Technical Service Information

FORD 4F27E

GEAR RATIO CHANGE

Figure 2

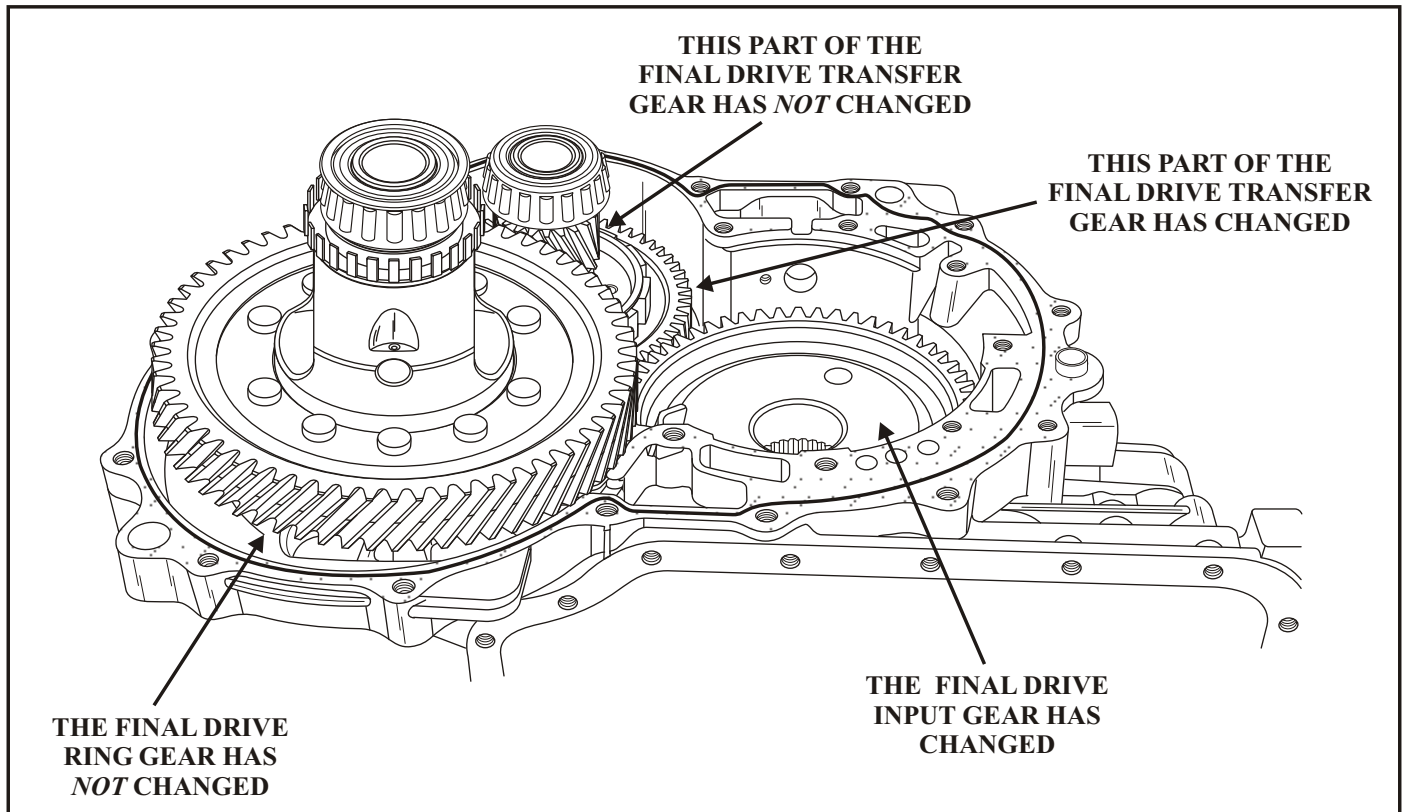
An example of the VCL can be seen in Figure 2. The location of the axle code is shown as well as the previous and current axle codes and gear ratios. The previous gear ratios are no longer available.

NOTE: These are the two previous gear ratios used for North American applications with automatic transmission
 NN = 3.693 Automatic
 WW = 3.904 Automatic

NOTE: These are the two current gear ratios used for North American applications with automatic transmission
 *PP = 3.733 Automatic
 XX = 3.956 Automatic
 *Could also be JJ or ZZ

Figure 3

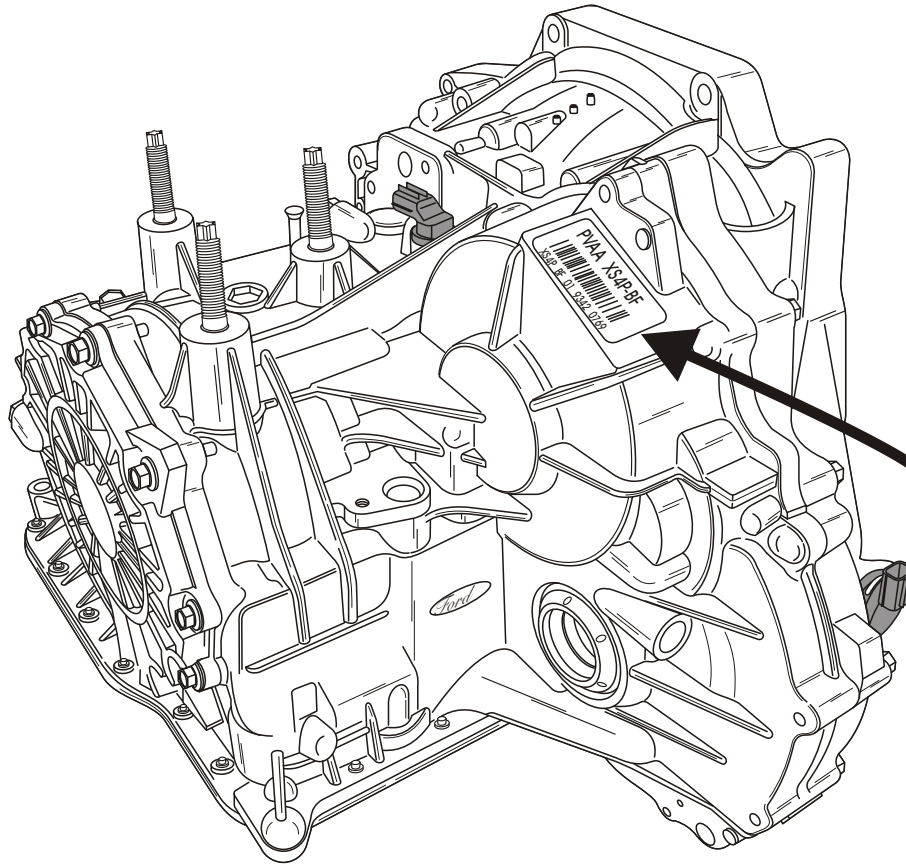
- (1) The final drive input gear tooth count has changed from 87 to 59 teeth.
- (2) The transfer shaft input gear tooth count has changed from 83 teeth to 57 teeth. The final drive ring gear and its mating gear on the input transfer gear have *not* changed as shown in Figure 3.
- (3) A new PCM calibration was made available to accommodate the new gear ratio. An authorized PCM modification label (Refer to Figure 4) should be placed near the vehicle emission label.

The new final drive input and transfer shaft input gears or a exchange transaxle that contains the new gear sets can be used in any 2000 or 2001 vehicle with a previous gear ratio as long as the PCM upgrade calibration is installed.
